FLORIDA POWER & LIGHT COMPANY

TURKEY POINT UNITS 3 AND 4

EMERGENCY POWER SYSTEM ENHANCEMENT PROJECT RESPONSE TO NRC'S REQUEST FOR ADDITIONAL INFORMATION (RAI'S) REVISION 1

MAY 1990

FIGURE 1-1
EPS ENHANCEMENT PROJECT
CIVIL/STRUCTURAL CRITERIA
(NOT TO SCALE)

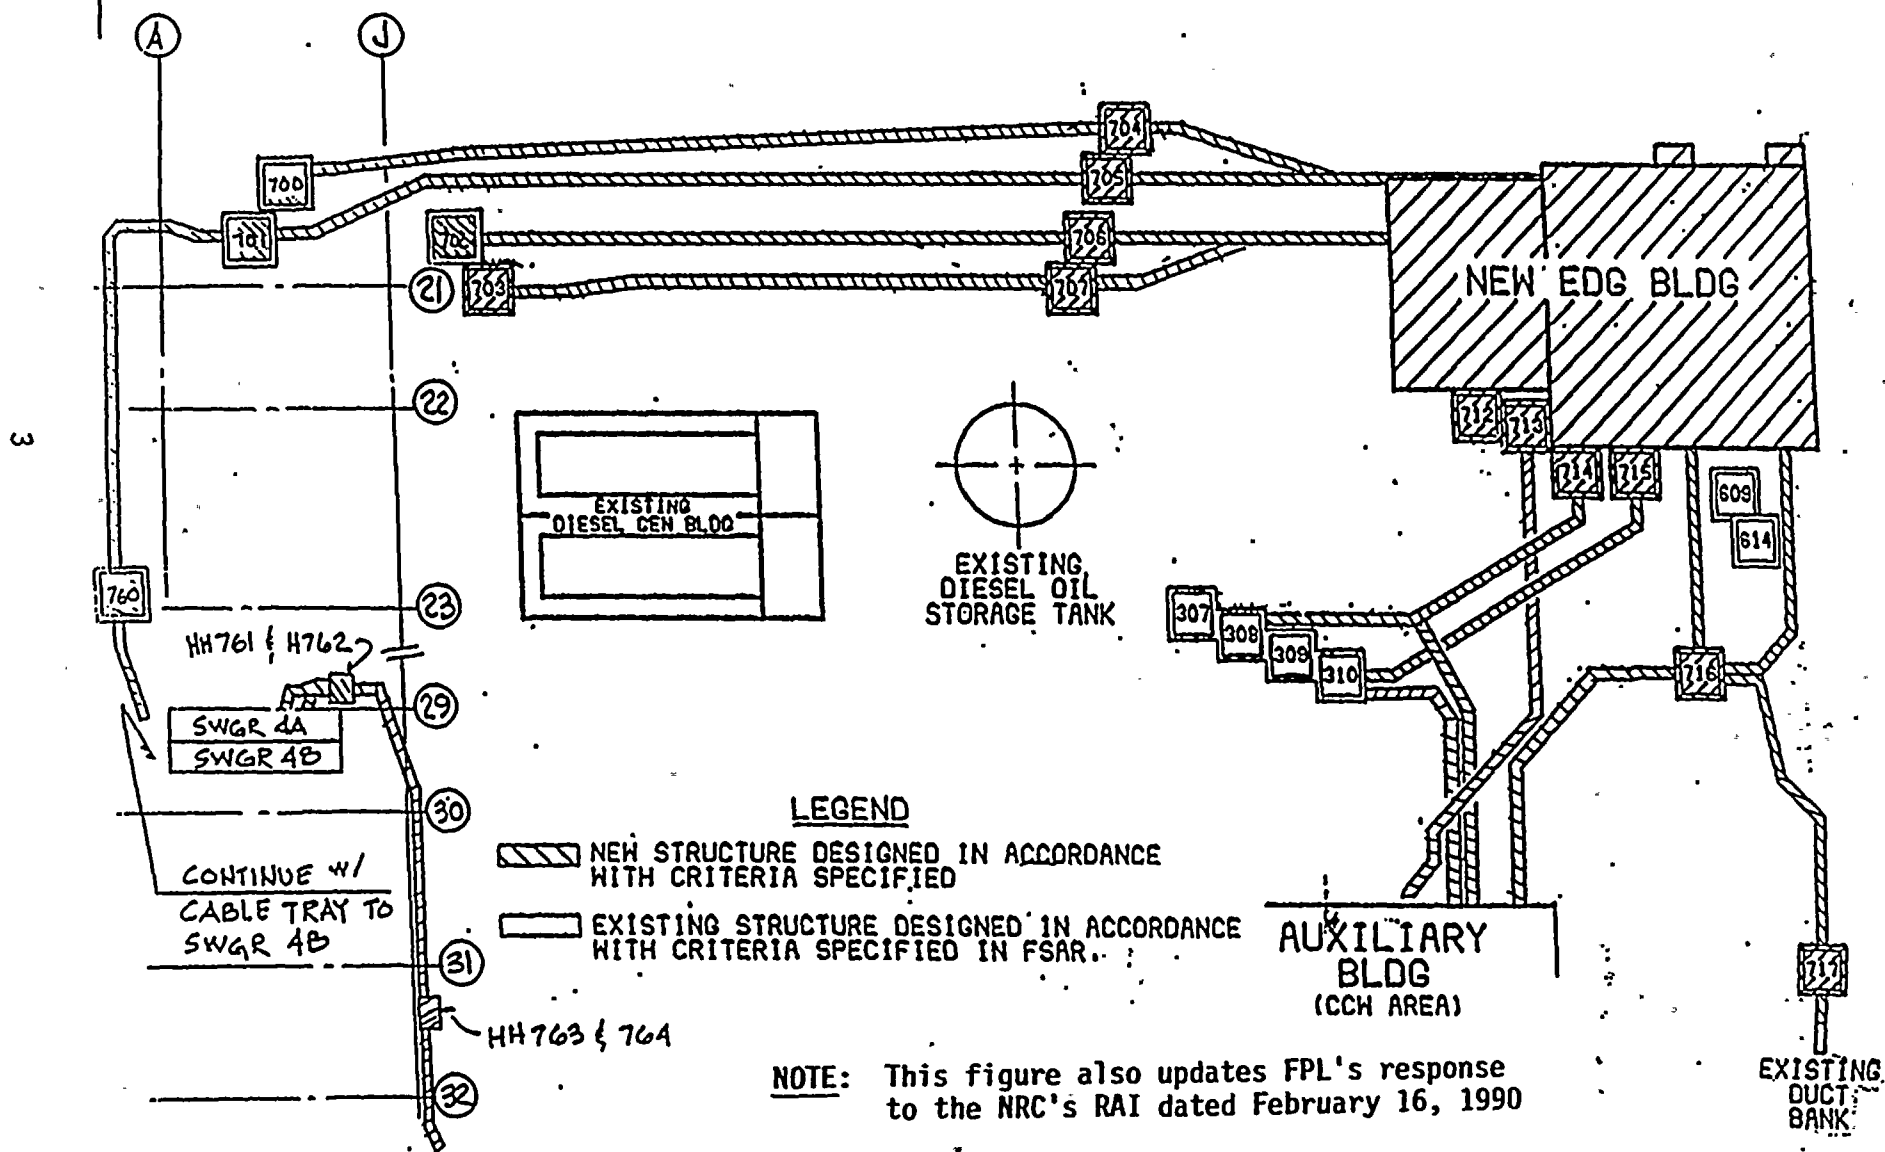
Identify the applicable Codes, Standards, Regulatory Guides, NUREGs, General Design Criteria, Generic Letters, and other documentation (hereafter "Standards") that are to be applied to the system enhancement. For each Standard identified, indicate to which part or parts of the system enhancement that the Standard will apply.

The new EDG building, all internal structures, and all new exterior structures (i.e., ductbanks and manholes) as shown on Figure 1-1 will be designed in accordance with the following criteria. Modifications and additions to existing structures will be designed in accordance with the criteria specified in the FSAR.

Missile protection will be provided for the new EDG building and new exterior ductbanks and manholes shown on Figure 1-1. Missile barriers will be designed to resist penetration and impactive dynamic loading in accordance with the criteria provided in SRP 3.5.3. The following missiles will be considered in barrier design.

FIGURE 32-1
COOLING SYSTEM HEAT TRANSFER CAPABILITY
(AT 110% RATED LOAD)

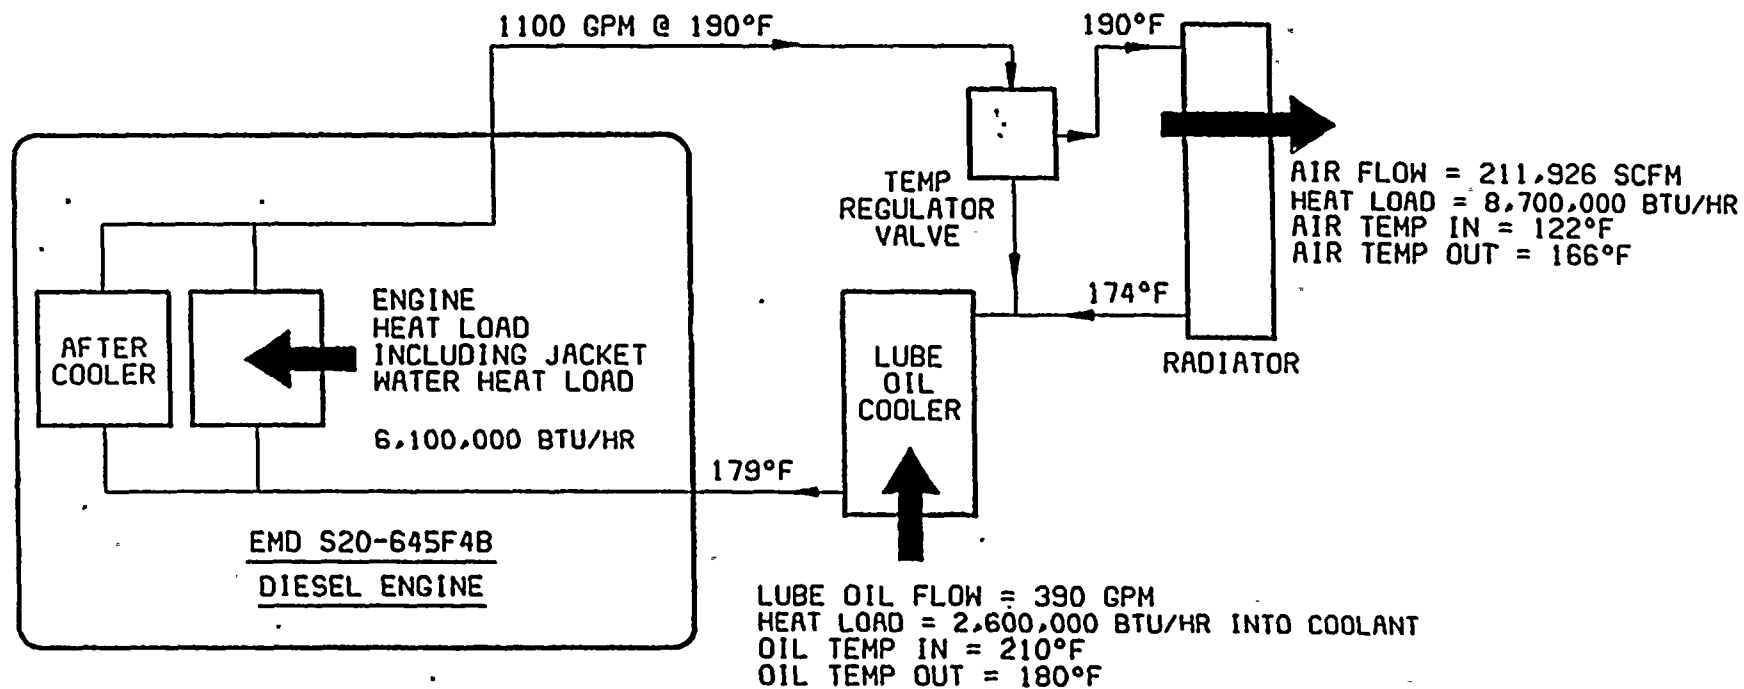
Provide a tabulation showing the individual and total heat removal rates for each major component and subsystem of the diesel generator cooling water system. Discuss the design margin (excess heat removal capability) included in the design of major components and subsystems.

The attached Figure 32-1 identifies the total and individual heat removal rates for the diesel generator cooling water system at 110 percent rated load. The cooling system is designed to maintain a top tank (water leaving the engine) temperature of 190°F at 110 percent rated load and radiator cooling air entering the radiator coils at 122°F. Since the engine is typically not operated at 110 percent rated load, the actual heat removal requirements are lower. The lower actual heat load constitutes design margin for the system.

BATH TUB CURVE

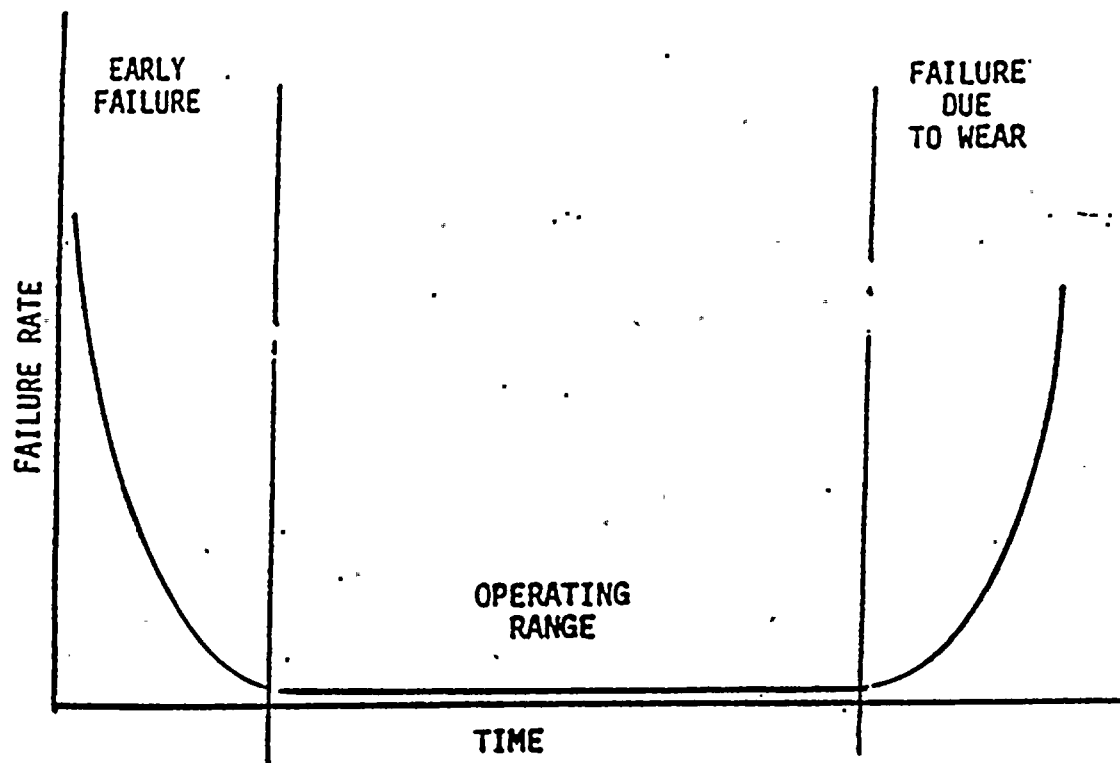
Provide information which illustrates how the stress margins of the 20 cylinder, single prime mover, F4B model compare to the 20 cylinder, E4 model that has undergone the 300 start and run tests.

It is our understanding that the TDI EDG utilized a custom made crankshaft to suit the torsional requirements for the installation. From a statistical point of view, the failure rate of a given component typically follows a "bathtub" curve as shown in Figure 53-1. Therefore, for a customized component, the likelihood of an early failure is greater than for a standard component with significant operating experience.

Based upon the total number of operating hours, all improvements are on the flat operating portion of the "bathtub" curve, well away from the early failure stage ((Figure 53-1).
